REVISED RESPONSE TO REQUEST FOR ADDITIONAL INFORMATION

APR1400 Design Certification

Docket No. 52-046

RAI No.: 255-8285
SRP Section: 03.08.05 – Foundations
Application Section: 3.8.5
Date of RAI Issue: 10/19/2015

Figure 1 Factor of Safety against Sliding at Each Time Step

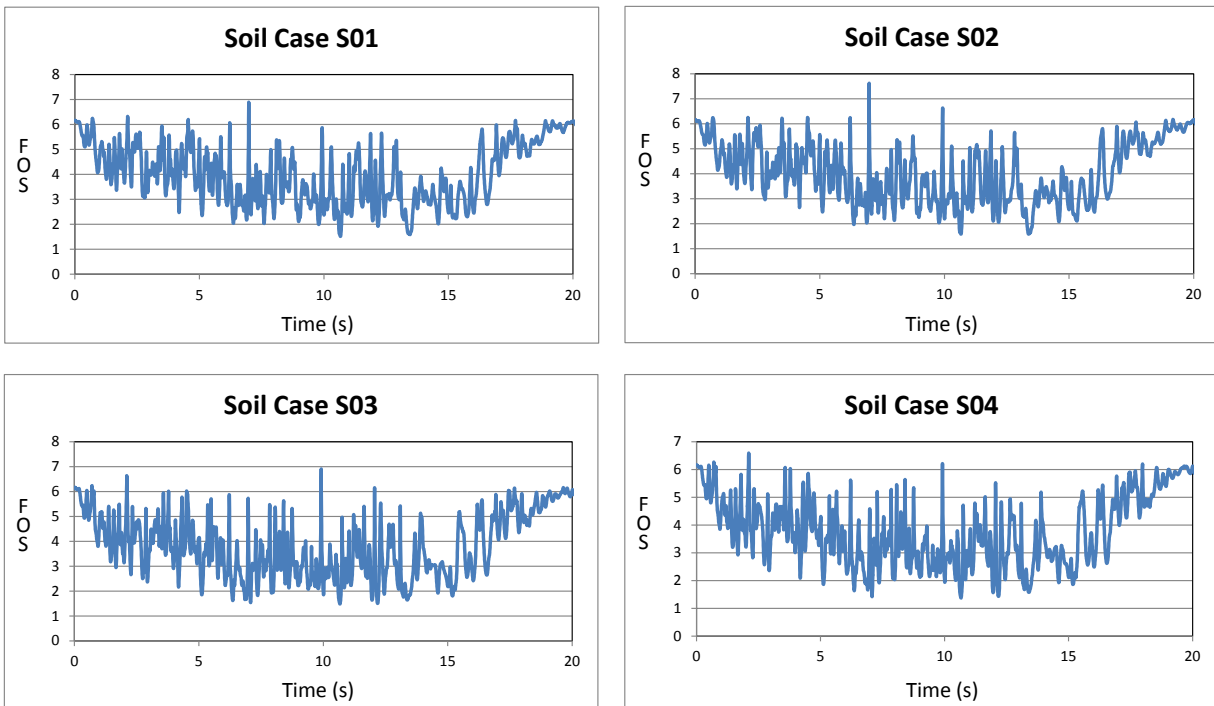
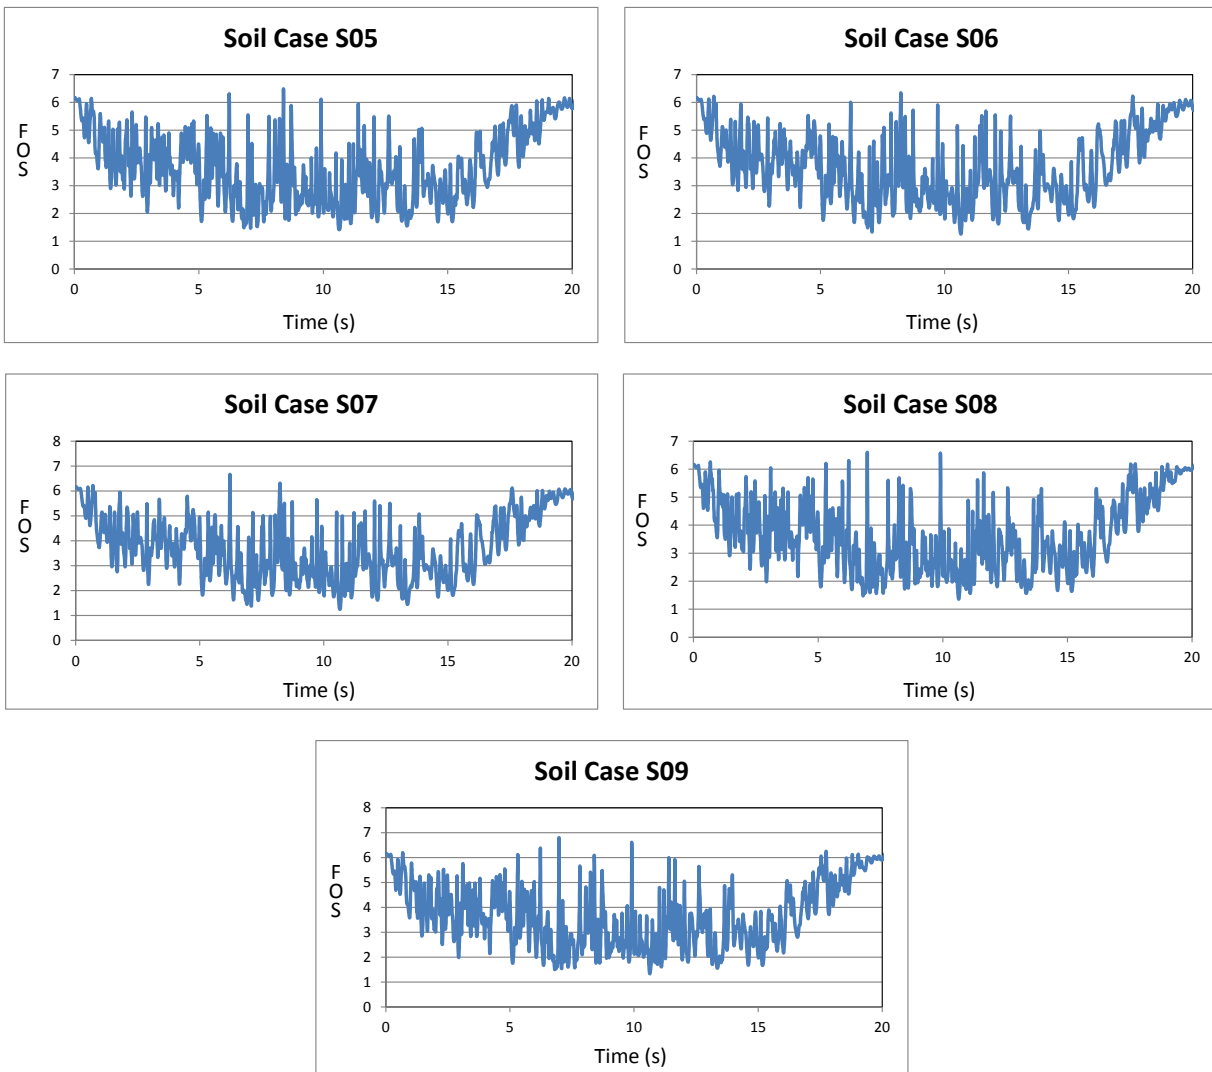
Technical Report (TR) APR1400-E-S-NR-14006-P, Rev. 1, "Stability Check for NI Common Basemat," Section 4.2.2, "Sliding Check," states that, "The resistance forces against sliding of the common basemat are checked for the driving shear forces generated for the seismic load. The basemat friction force is considered to resist the sliding of the common basemat." The applicant further stated that coefficient of friction for sliding check is 0.7. The applicant's approach for evaluating the sliding analyses of the Category I structures is not clear to the staff. SRP 3.8.5 II.4.G and B provides the criteria for determining the sliding forces and overturning moment of the Category I structures subject to seismic loads. Per 10 CFR 50.55a; Appendix A to 10 CFR Part 50, General Design Criteria 1, 2, 4, 16 and 50; and SRP 3.8.5, the applicant is requested to provide a detail description of the method used to determine the sliding check of the Category I structures; and to justify that the coefficient of friction of 0.7 represents the minimum coefficient of friction considering the various sliding interfaces including concrete to soil, waterproofing to soil, and concrete basemat to concrete mudmat.

The factor of safety (FOS) against sliding is calculated at each time step ($t = 0 \sim 20.48$ seconds with an interval of 0.005 seconds) for each soil case (S01 ~ S09; S10 is a fixed base case), i.e., by linear time history method. The final result is shown in Table 3 and Figure 1 below.

Finally, the minimum FOS against sliding during the entire time period and for all soil cases is obtained as 1.25, as shown in Table 3.
